## Meeting Agenda Design Review Board

**DESIGN REVIEW BOARD**  
**for**  
**1500 Holleman Drive East**  
**AWV2023-000012**

- REQUEST:** Waiver to UDO Section 7.10.C.3.a.1, Horizontal Façade Articulation, to not provide the required Horizontal Façade Articulation on the primary façade
- SCALE:** 2.0 acres
- LOCATION:** Lot 1, Block 2, of the Post Oak Mall Subdivision, generally located at 1500 Holleman Drive East
- ZONING DISTRICT:** WPC Wolf Pen Creek
- APPLICANT:** Sterling Thompson, Sterling and Kap Architects, LLC
- PROJECT MANAGER:** Jeff Howell, Senior Planner  
jhowell@cstx.gov
- RECOMMENDATION:** Staff recommends approval of the waiver.

UNION OAK FOOD MARKET  
(FORMER SEARS HOME SERVICES)  
- REMODEL

**Elevation- Façade 'A'**

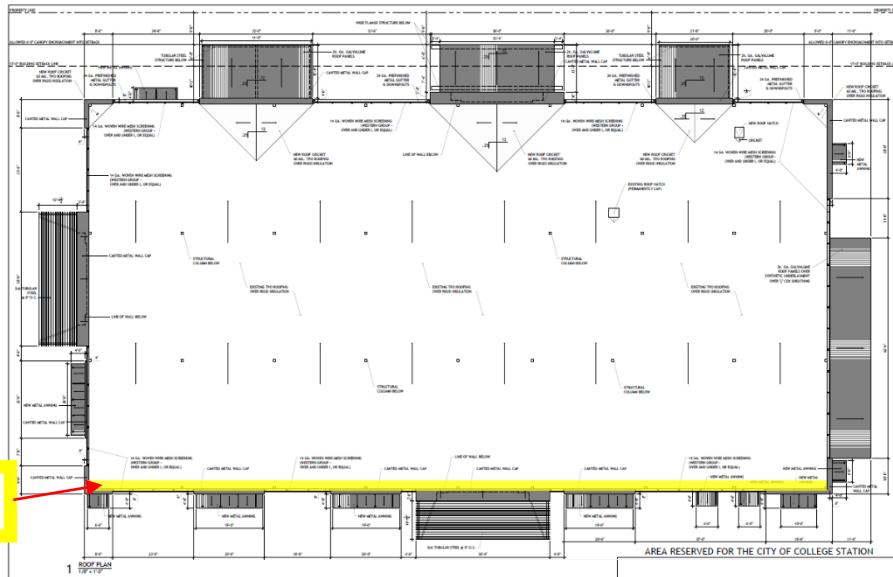
A new tenant, Union Oak Food Market, is looking to redevelop the property and update all façades of the existing building. The existing building, constructed in 1981 of concrete block, provides minimal articulation of the primary façade, which is just over 211 feet in length. Currently, there are 5 bay doors for trucks, a service entrance, and a main entry door covered by a canopy. This is proposed to be replaced with windows, doors, and several relief elements in order to meet the Architectural Relief Element requirements, one of which includes a metal canopy structure as an entry element. While this element is indicated to be about 38 feet long, it is not considered a wall plane projection and therefore does not meet the minimum depth requirements of 4 feet, nor does it meet the required minimum width requirement of 33% of the entire façade (69 feet 9 inches). Therefore, the applicant is requesting that the DRB waive the requirement to provide the Horizontal Façade Articulation of the primary façade found in Section 7.10.C.3.a.1.

The applicant states that alterations to the existing structure would be required in order to meet the requirements of the ordinance and that the structural integrity would be affected. It was also stated that adding the required projection would add unnecessary structural issues and cost while not adding functional interior space. The applicant also states that the proposed metal canopy, as well as other articulations, are provided to leave less than half of the façade remaining on the same plane.

Staff recommends approval of the waiver request.

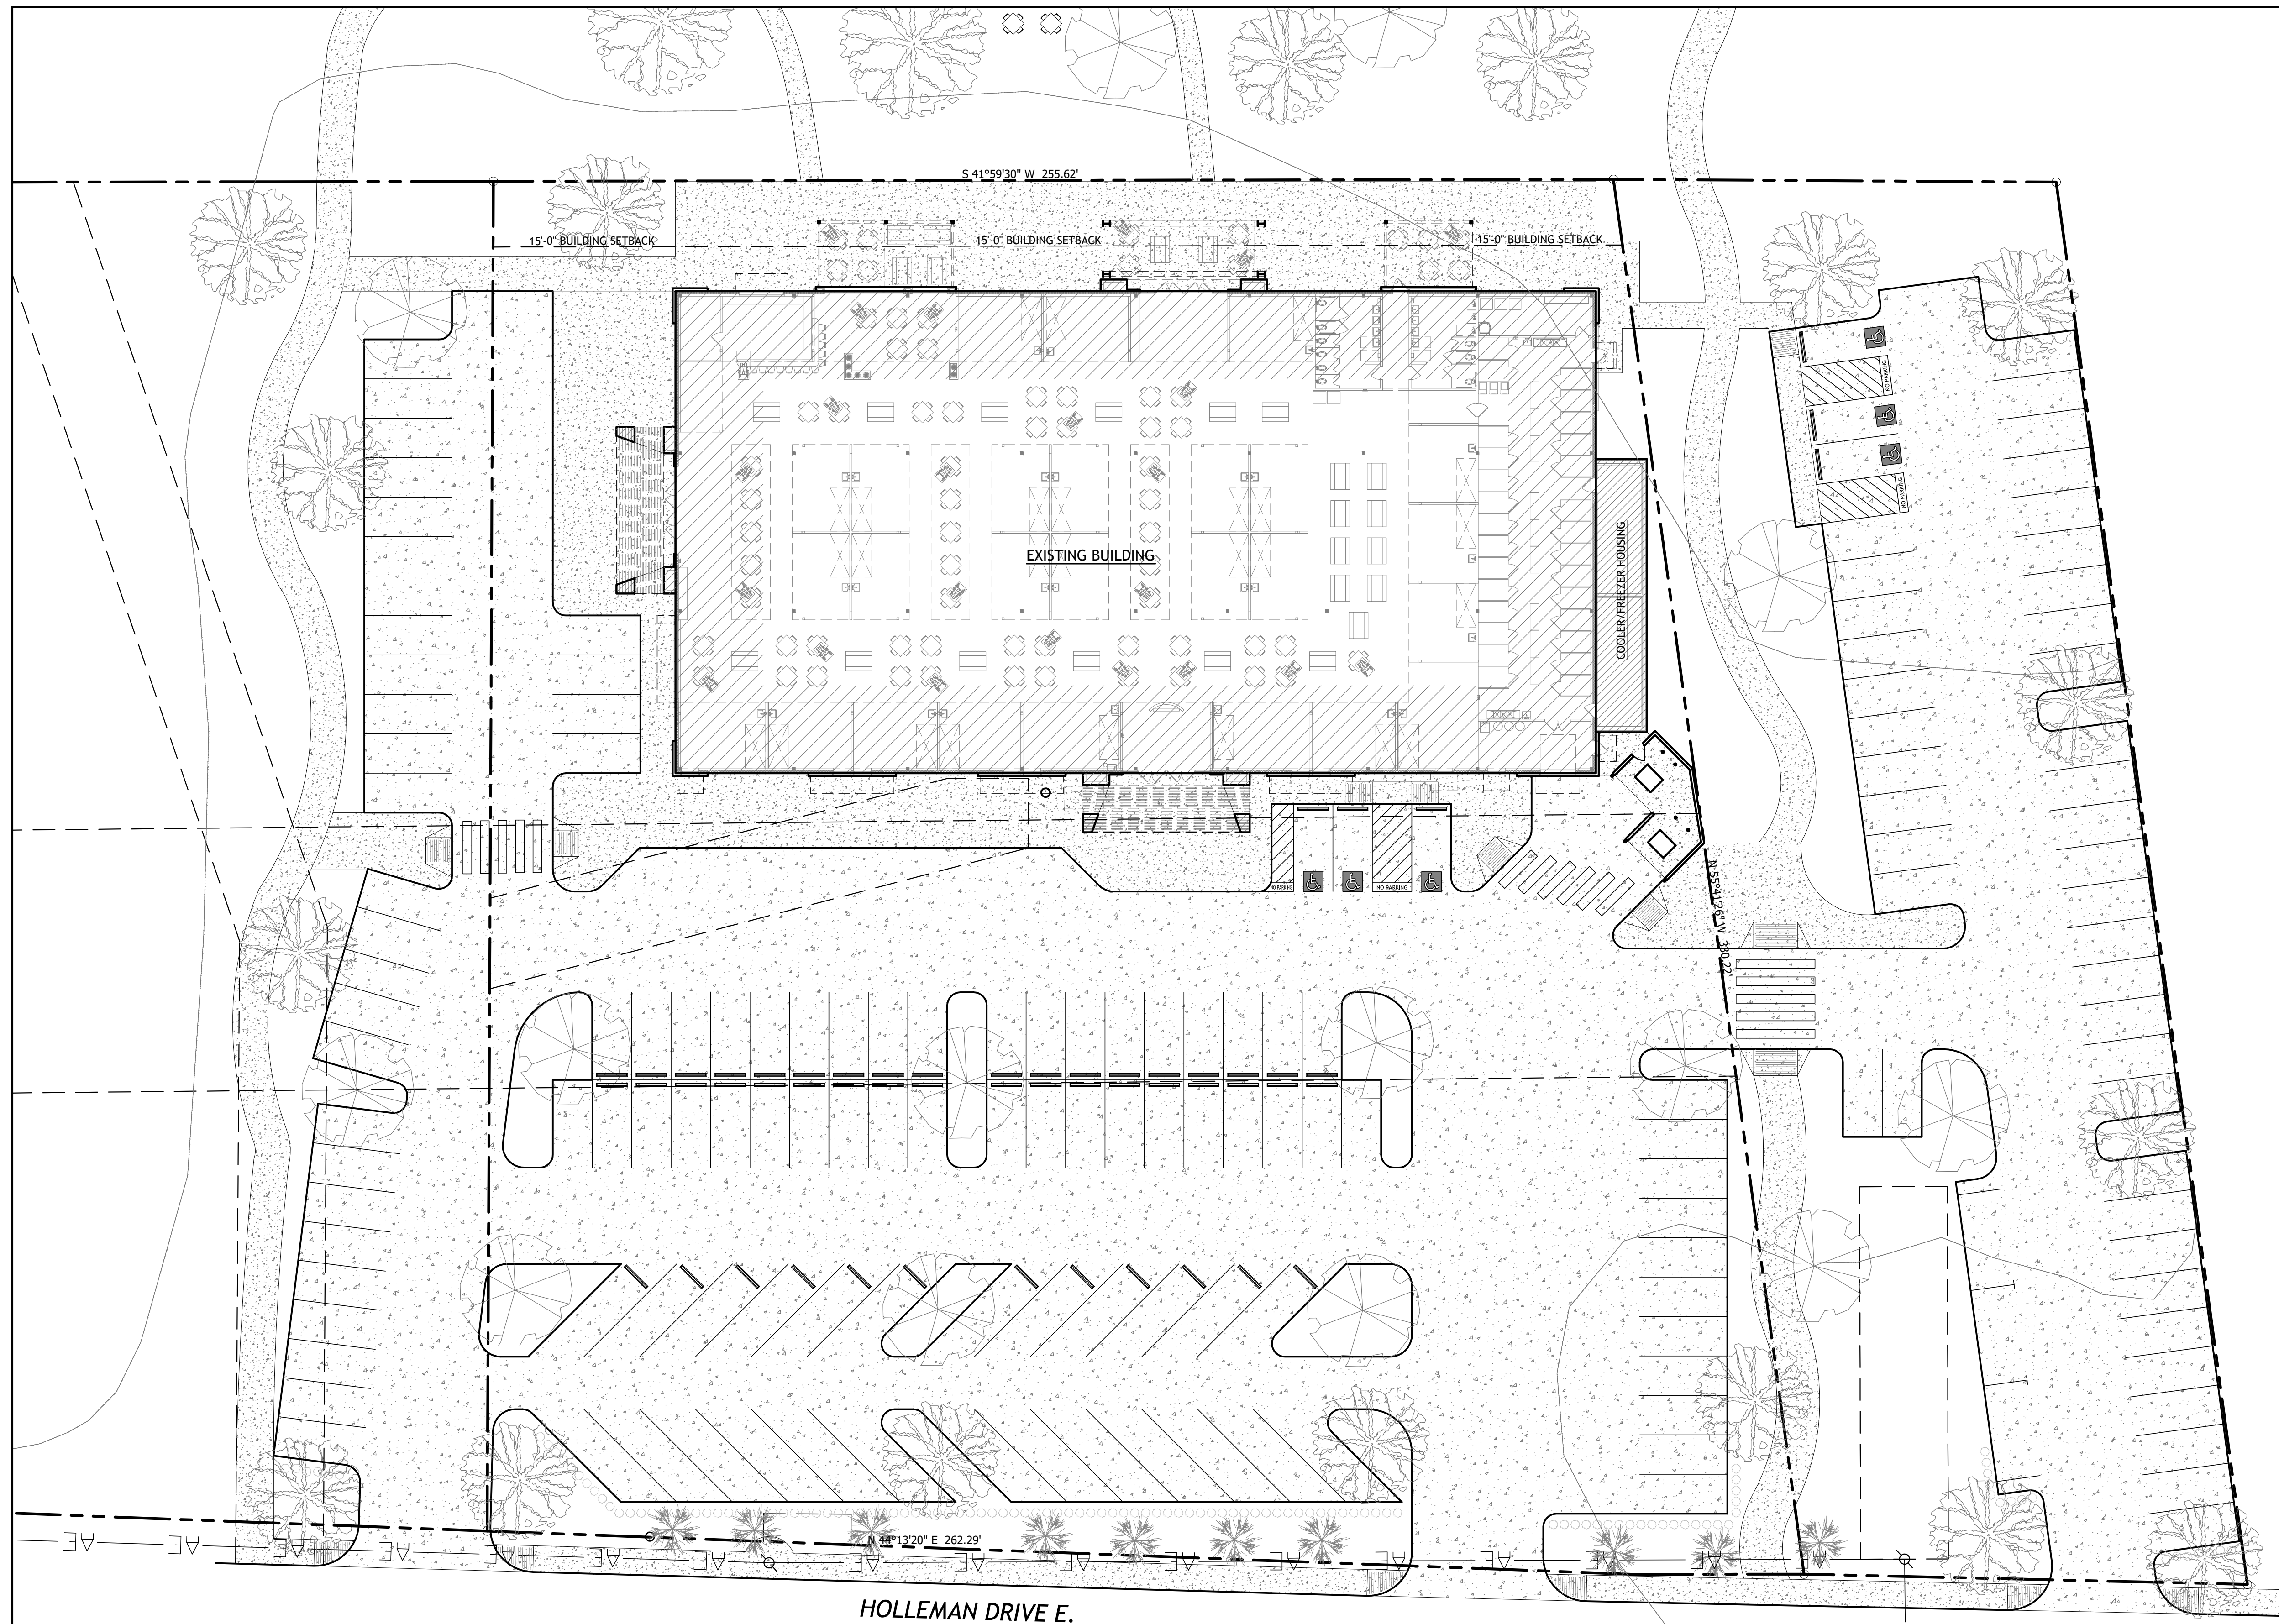
Currently, as designed, there is an existing 211'-4" foot long front facade.

projection ( 18% ) that projects greater than 4', as an entry element. We have also given the facade articulation using different materials for a total of another 86 feet or 40 %. These articulations do not project the four feet but are attached to the facade and project above the roof as a parapet to conceal rooftop equipment. These articulations also have awnings that do project four feet from the facade. This leaves about 42% of the existing facade in the same plane.

In my professional opinion, enough interest has been created with the front facade with the design as we've presented it. Adding four foot projections to this existing structure would add unnecessary structural issues and cost to the project while adding nothing to the functionality of the interior space. Therefore we respectfully request this variance.

**1** FACADE 'A' (FRONT ELEVATION) - ARCHITECTURAL  
 1/8" = 1'-0"

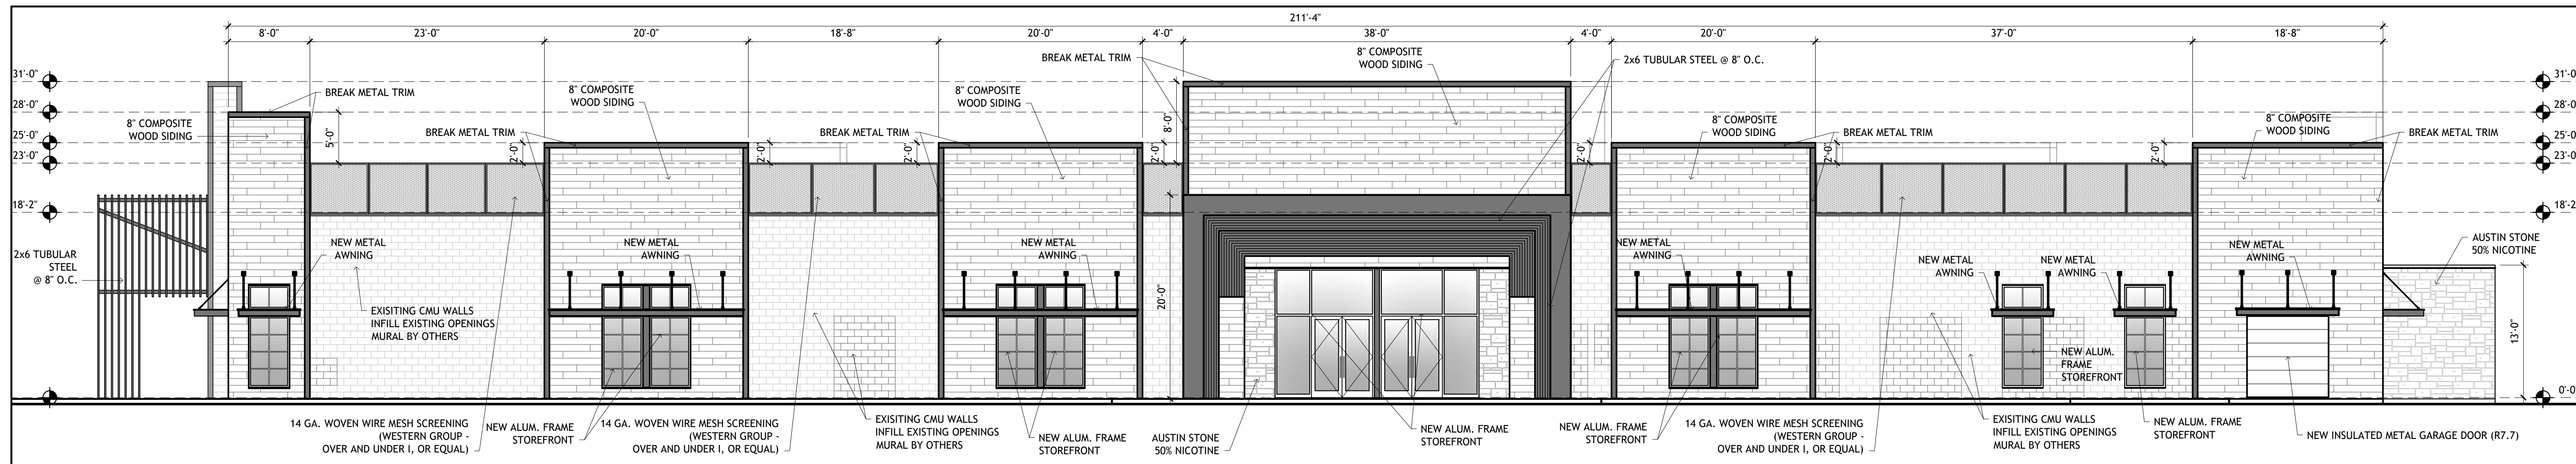
We are asking a waiver to the Horizontal Façade Articulation that would require our proposed wall plan projections on the primary facade to have a minimum depth of 4'-0"

This is an existing building that in its present form is a 210' long x 110' deep x 18' tall box composed of concrete block walls with little-to-no horizontal articulation. We are already proposing several changes visual changes in terms of changes in exterior cladding, adding awnings/canopies, and new parapet articulation

We are already providing horizontal facade articulation but the areas we are bumping out from the wall with materials such as stone and wood siding across all four facades to contrast with the plan, flat existing concrete

We do have a number of metal awning across the front that do extend 4'-0" past the façade. The structure over the main entrance extends nearly 13'-6" past exterior wall of the existing building.
